URBAN DESIGN COMMISSION APPLICATION

Title: Wisconsin History Center

URBAN DESIGN COMMITTEE SUBMITTAL

This addendum is developed specifically towards the recommendations received at initial approval:

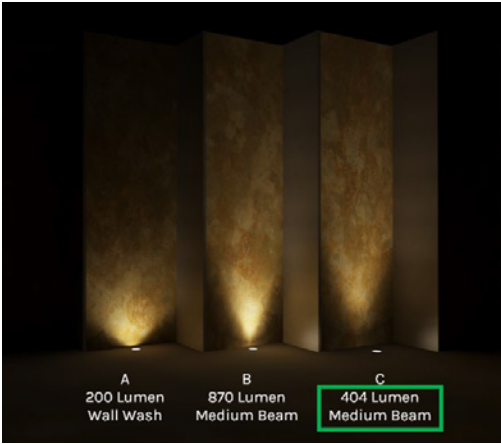
- 1) **Show an alternate to the materials selection using zinc panels more consistently, one that the design team would be open to and comfortable presenting.**

We acknowledge that certain committee members expressed a preference for increased zinc usage in the design through consistency. Additional renderings have been included within the submission to better reflect key arrival perspectives from State Street, Mifflin St, and along Carroll St. in which the Zinc will appear higher in quantity. We hope this better communicates the project's intent to appropriately balance the material palette while certainly letting the Zinc be more prominent at times as some on the commission seeked. We have intentionally chosen to incorporate these two prominent materials due to their extensive history of mining in Wisconsin by various cultures.

The design seeks to harmonize the unique qualities of both materials. Situated at the intersection of Carroll, State, and Mifflin Streets, our primary objective is to establish an inviting and "bright" gateway to downtown Madison's cultural district. Although weathered Zinc possesses its own aesthetic appeal, using it as the predominant material would result in a visually imposing and dark building structure.

Stainless steel allows the building to subtly reflect the surrounding context, symbolically paying homage to downtown Madison and allowing one to feel physically and metaphorically part of the museum.

By incorporating weathered zinc and bead blasted stainless steel into the building's design, we pay homage to the historical significance of these materials in Wisconsin. They not only add aesthetic appeal but also evoke a sense of longevity, endurance, and the evolving narrative of the state. Through their visual and symbolic presence, these materials become an integral part of the building's identity, connecting it with Wisconsin's heritage and the enduring spirit of its people.

EXTERIOR LIGHTING COMPARISON

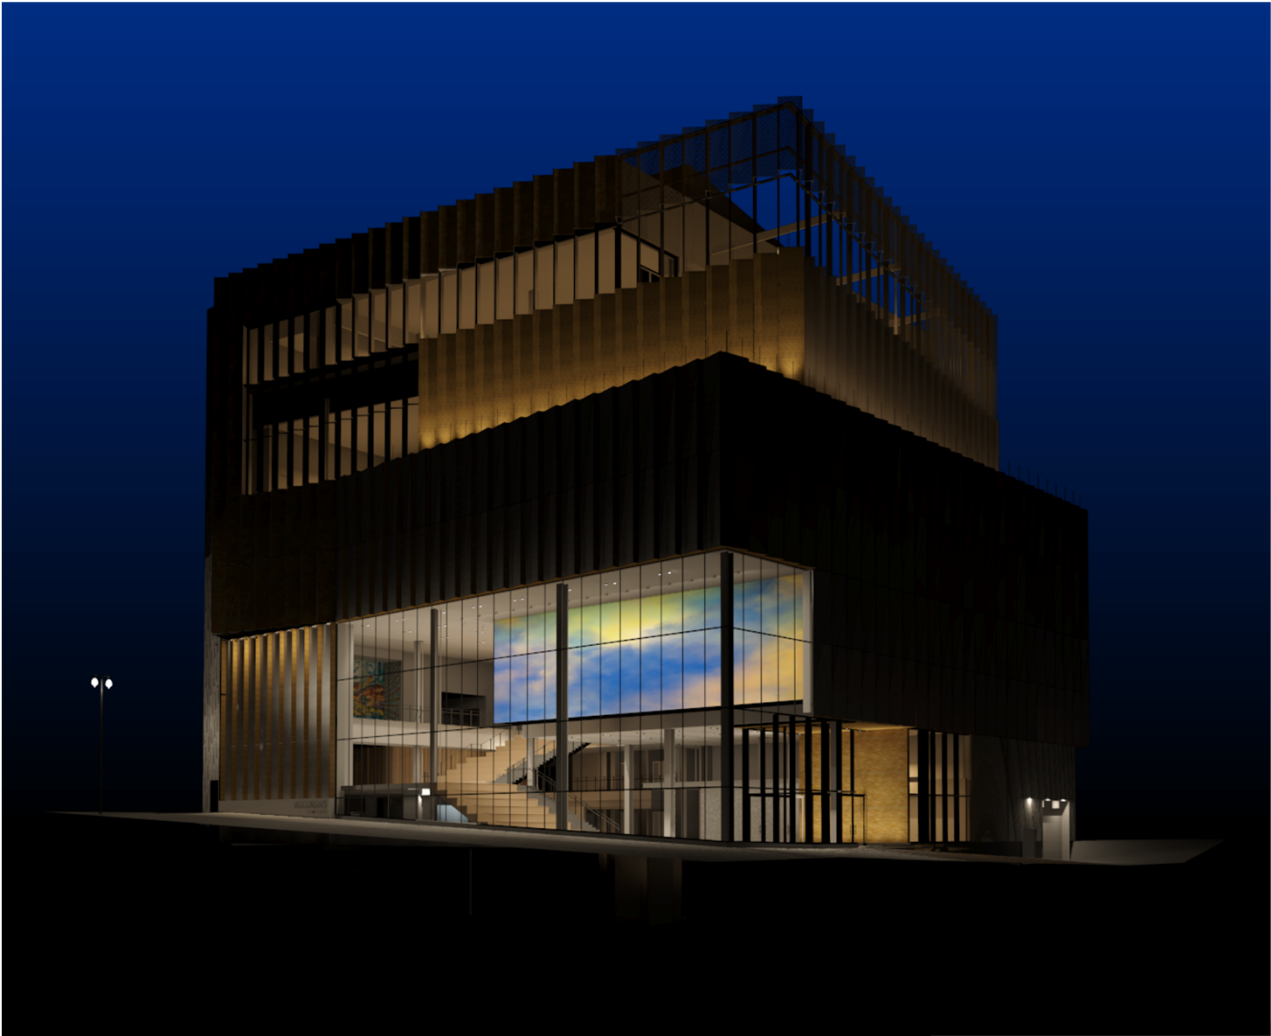
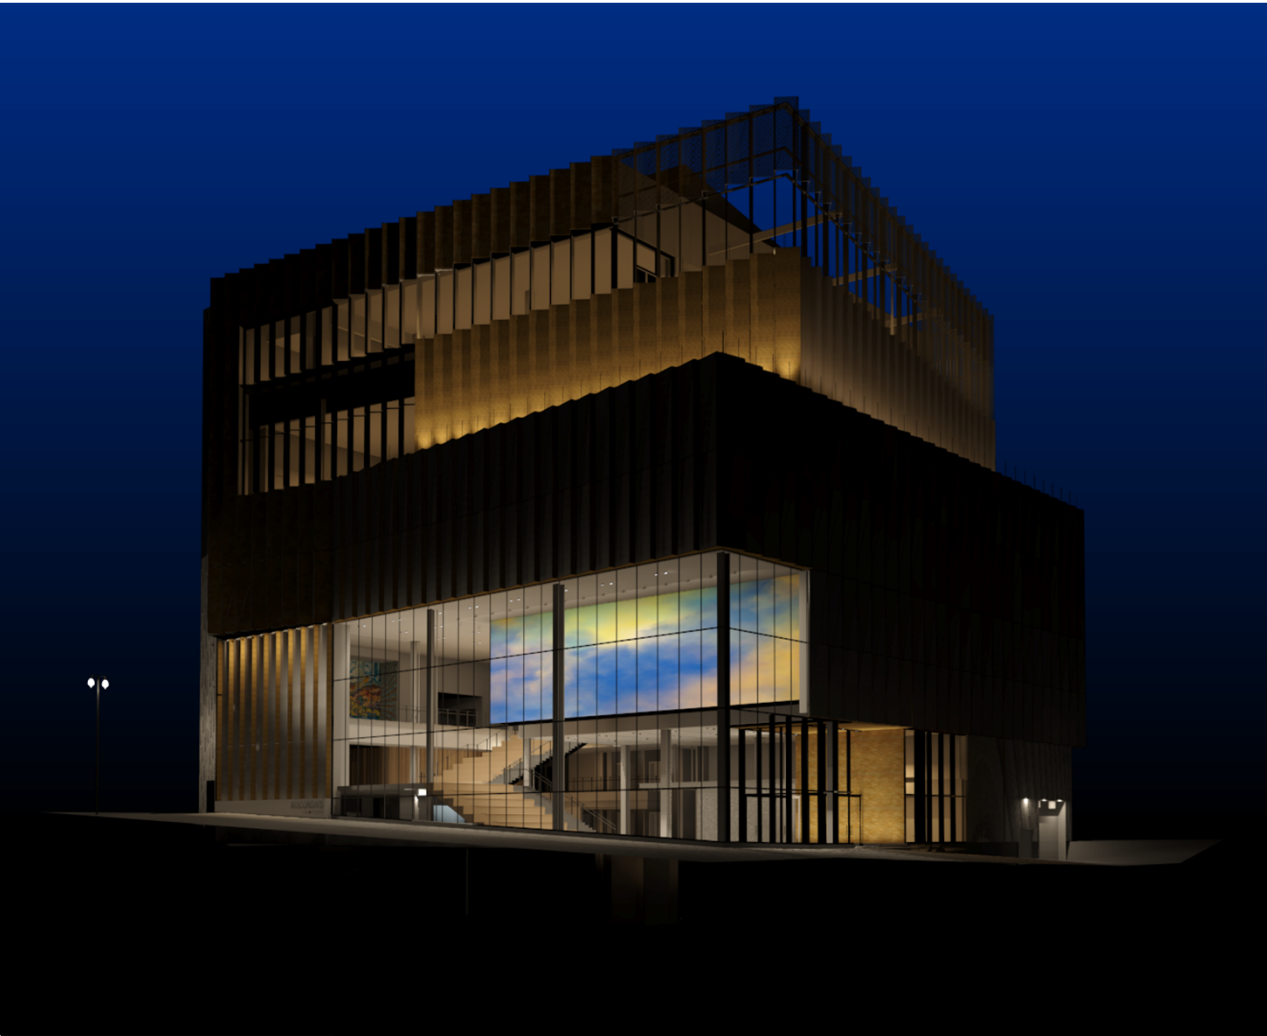
- 2) **Provide additional information to the Commission to better understand the resolution of the proposed exterior lighting.**

The design team has proposed a compliant yet higher lumen output fixture and its supporting detailed documentation related to the installation. We feel this solution provides a great balance of accent lighting reaching higher on the façade panels through soft illumination while remaining below the required lumen threshold.

404 Lumen
Medium Beam
Recommended for compliance,
maintained effect

FIXTURE TYPE “XL3” PHOTOMETRIC STATISTICS

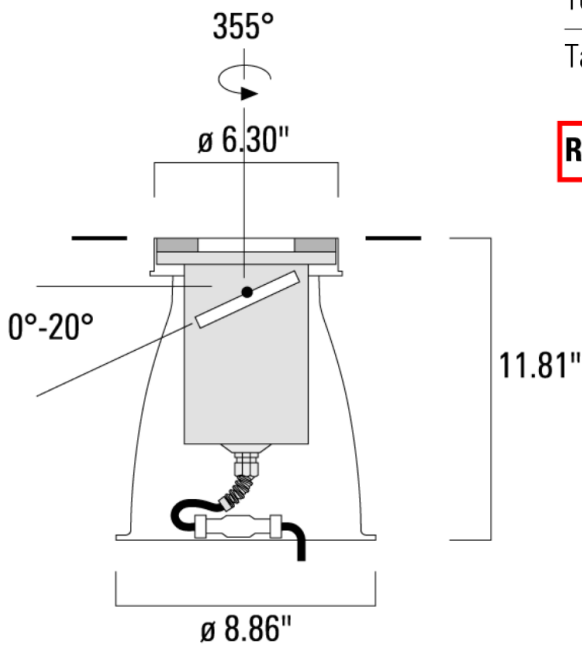
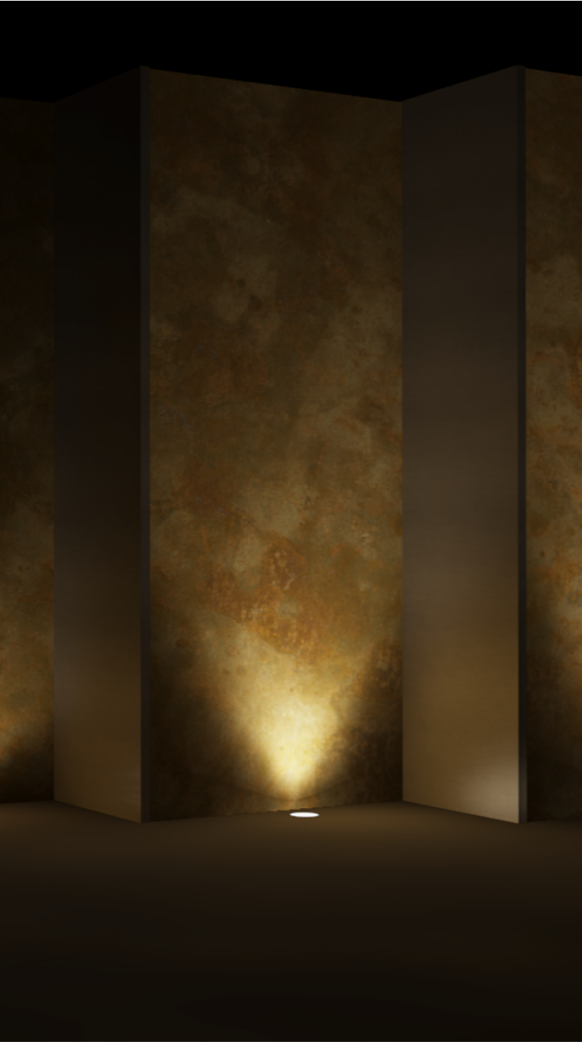
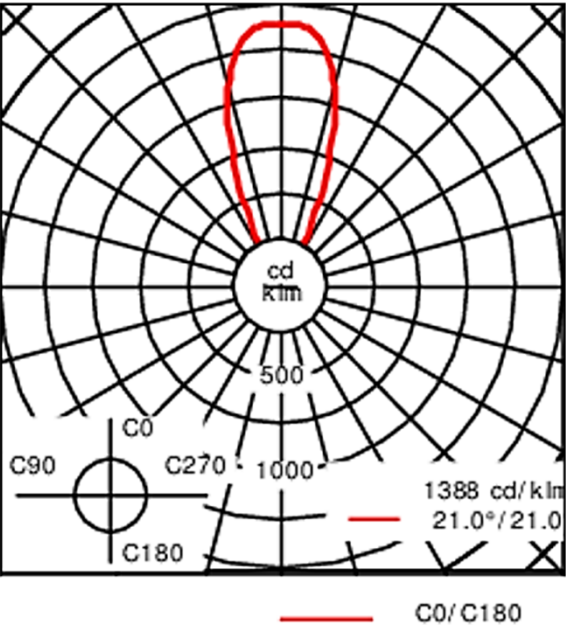
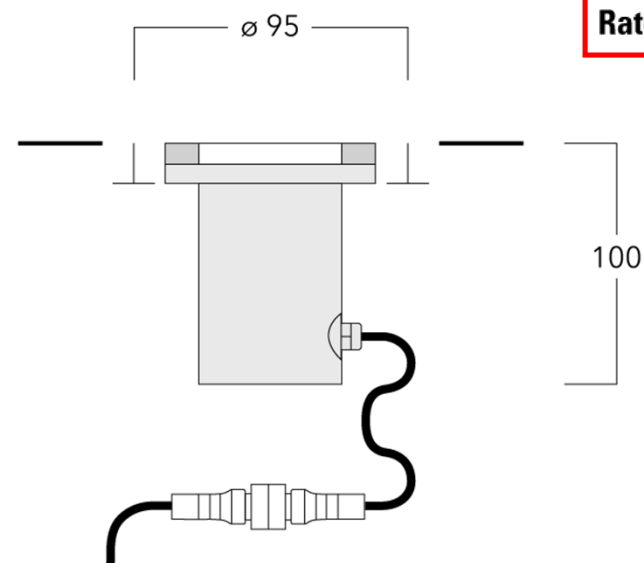
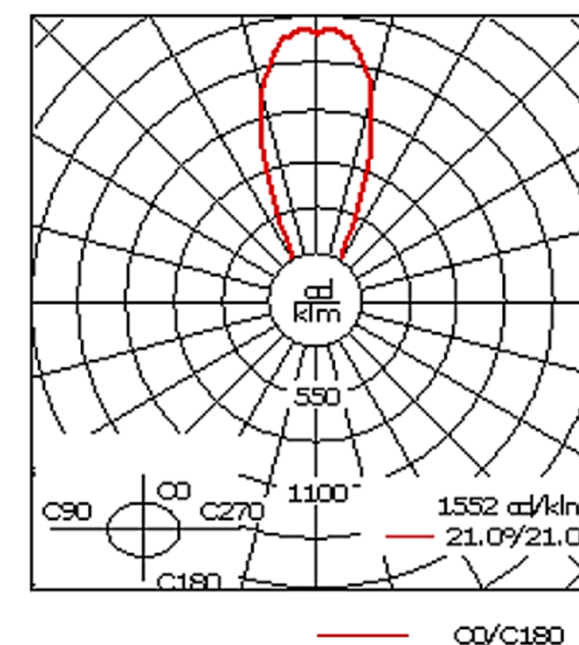
Previously
documented

**Recommended for
compliance, maintained
effect**

POINT BY POINT CALCULATION

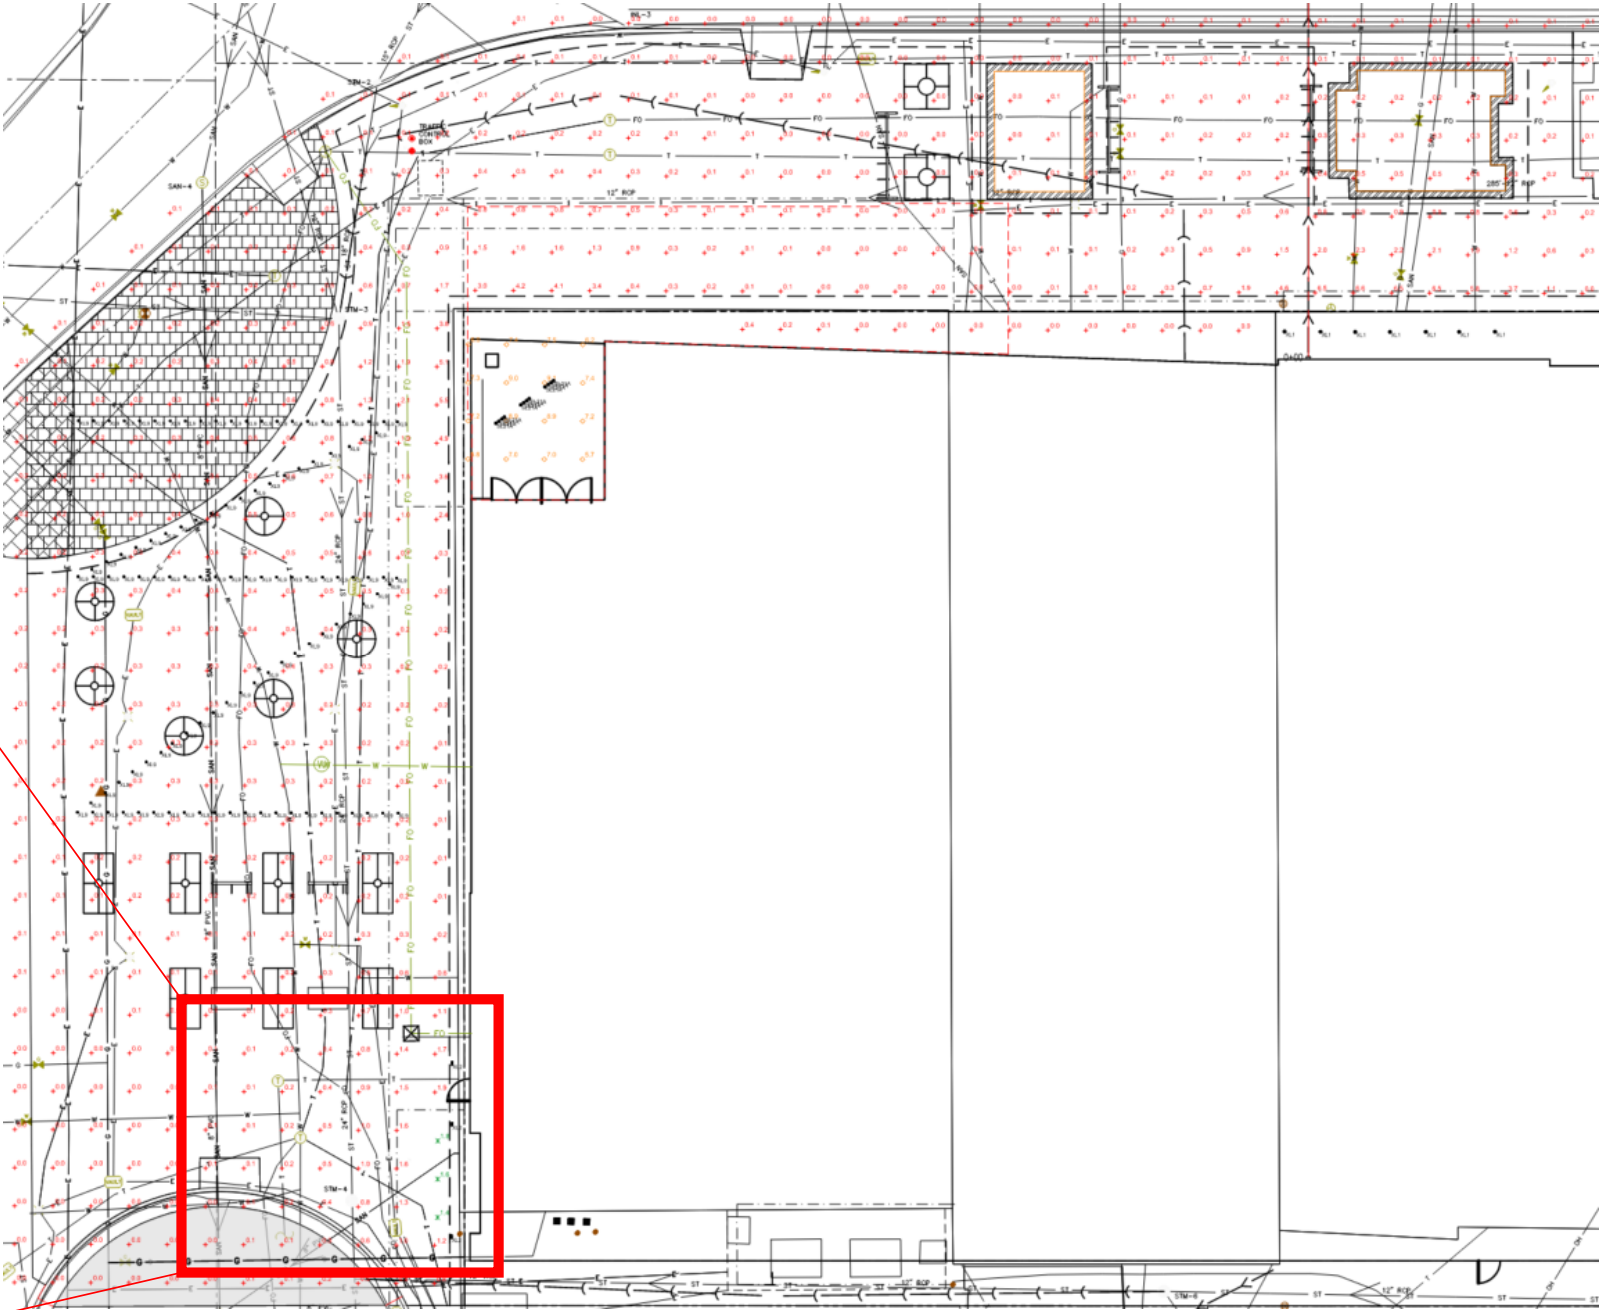
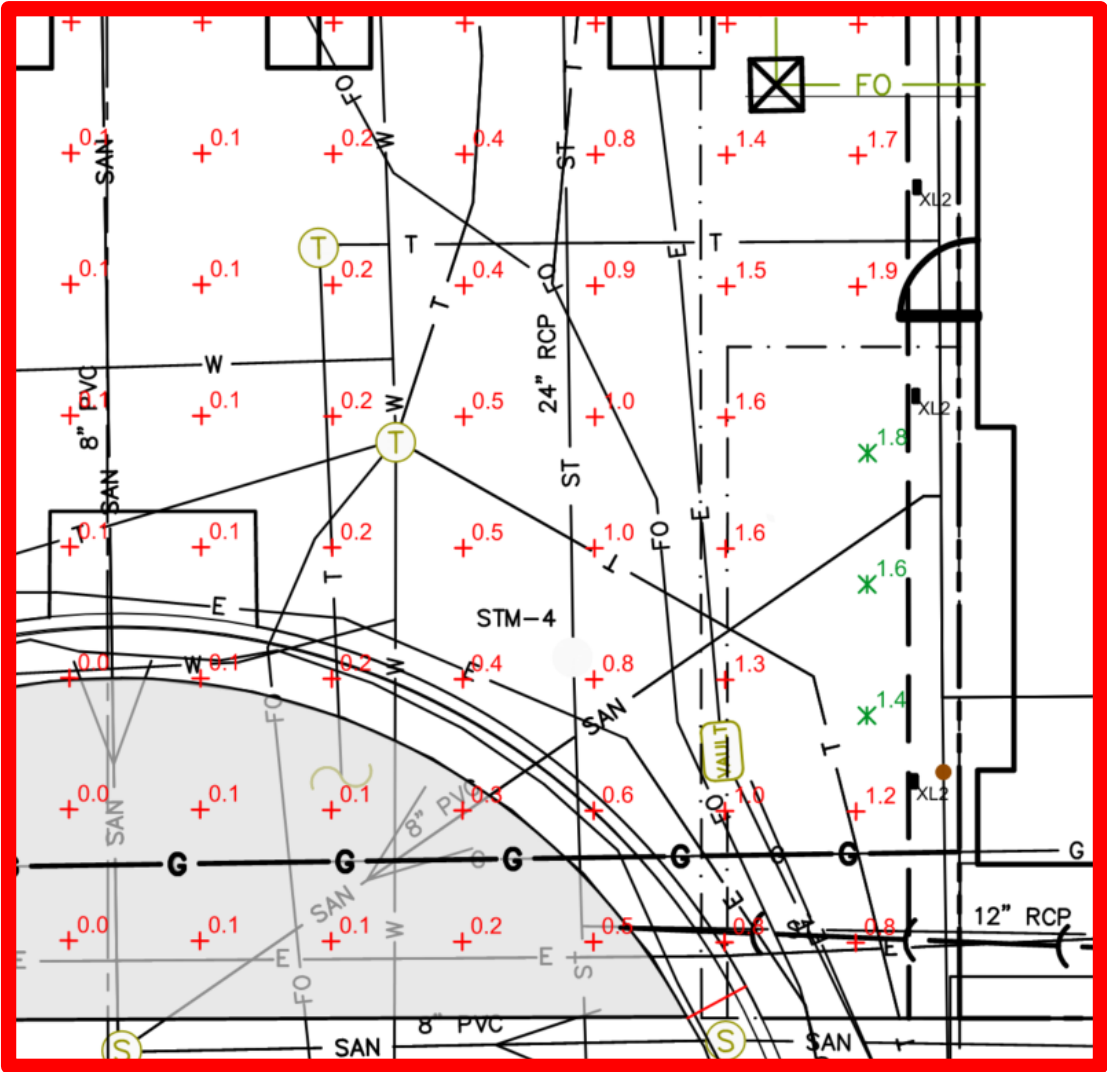
Point by point illuminance calculations are updated based on the latest lighting layout from 08.09.23. Per comments, and City of Madison Building Code – 29.36, type XL2 loading dock fixture has been modified to We-ef “RLS410 LED” full cut-off wall pack to achieve 1.5 fc average.
